Docket No. 94-CE-28-AD; Amendment 39-9472; **AD 95-26-13**

Airworthiness Directives; The New Piper Aircraft, Inc. (formerly Piper Aircraft Corporation)
PA28 and PA32 Series Airplanes
PDF Copy (If Available):

ACTION: Final rule.

95-26-13 THE NEW PIPER AIRCRAFT, INC.: Amendment 39-9472; Docket No. 94-CE-28-AD; Supersedes AD 76-25-06, Amendment 39-2788.

Figure 1

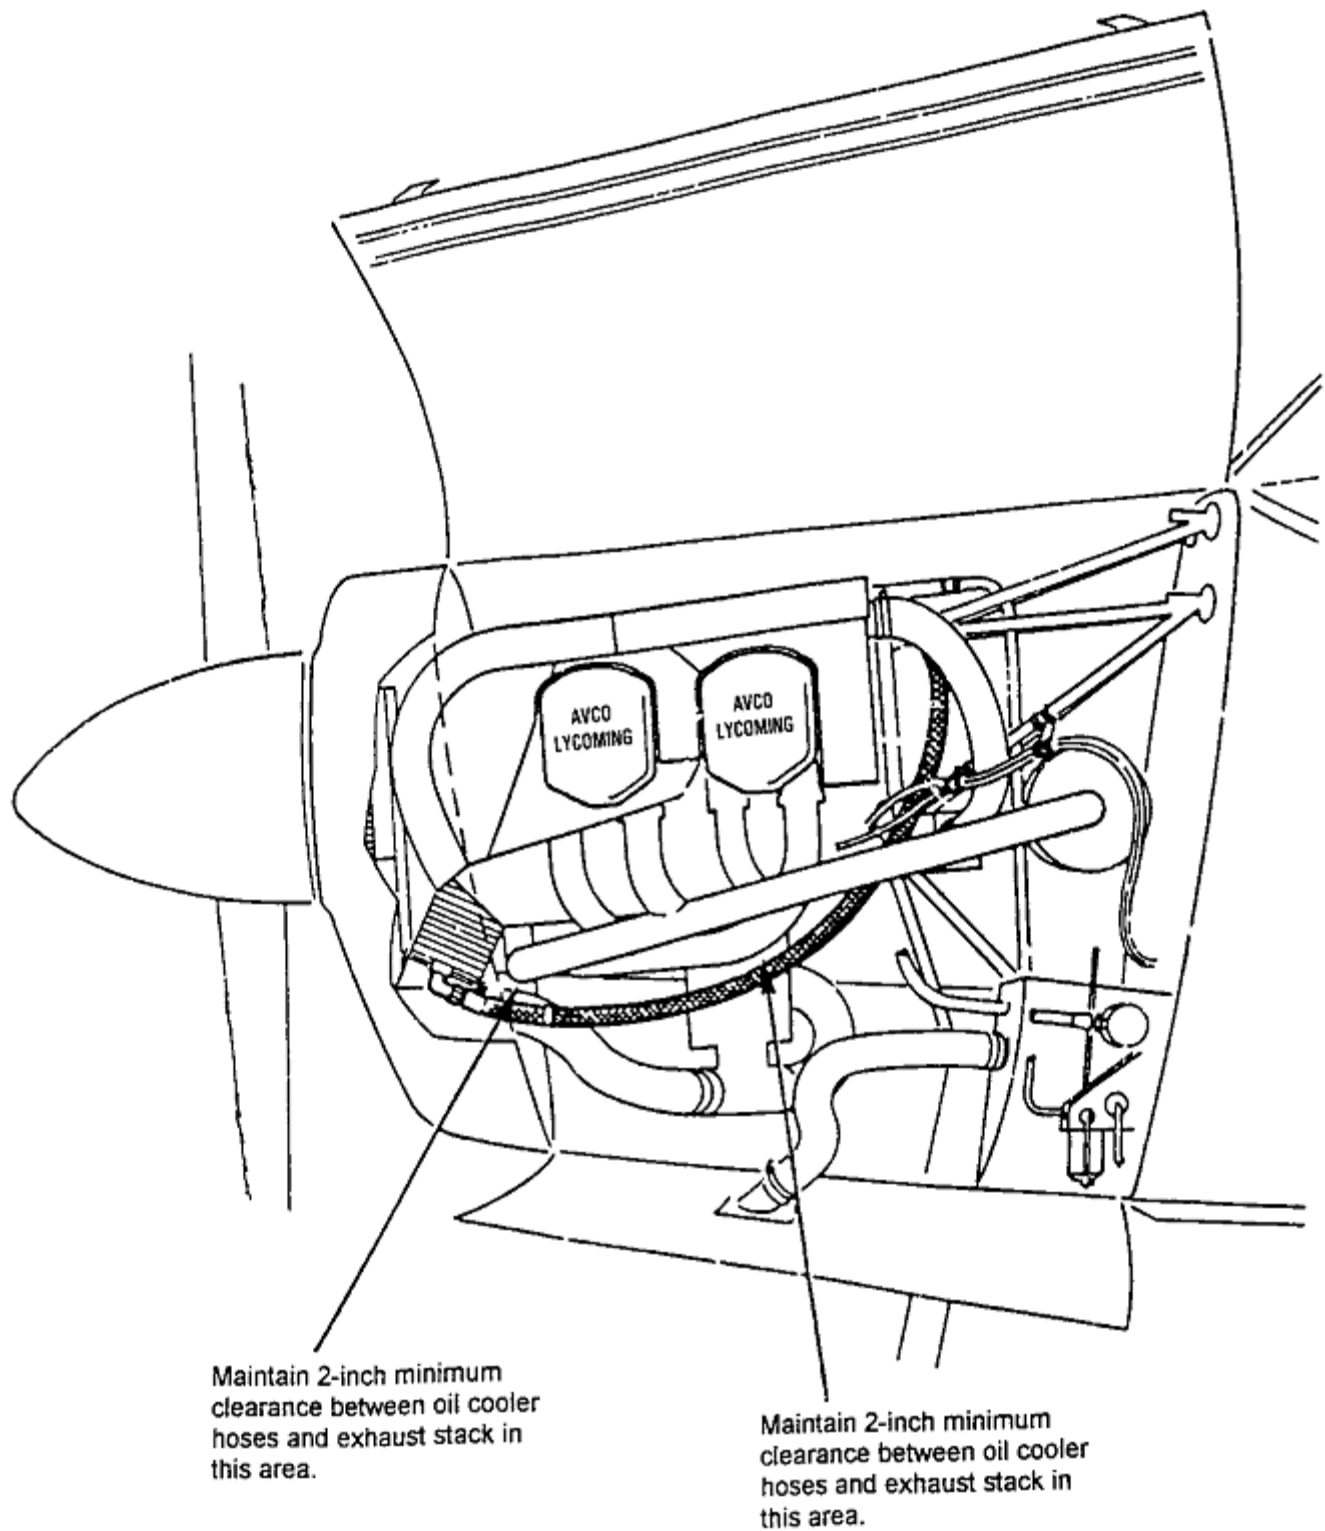
(2) On airplanes that have any oil cooler hose assembly mounted in the front of the airplane, ensure that the following exists, and, prior to further flight, adjust accordingly:

(i) The hose passes underneath and behind the electrical ground cable and in front of the lower of the two engine mount struts when the hose is routed to the rear of the engine; and

(ii) The hose is tied to the engine mount strut and a clearance of at least 2 inches exists between the oil hose and exhaust stack.

NOTE 2: Figure 1 of this AD relates to the conditions specified in paragraphs (a)(2)(i) and (a)(2)(ii) of this AD.
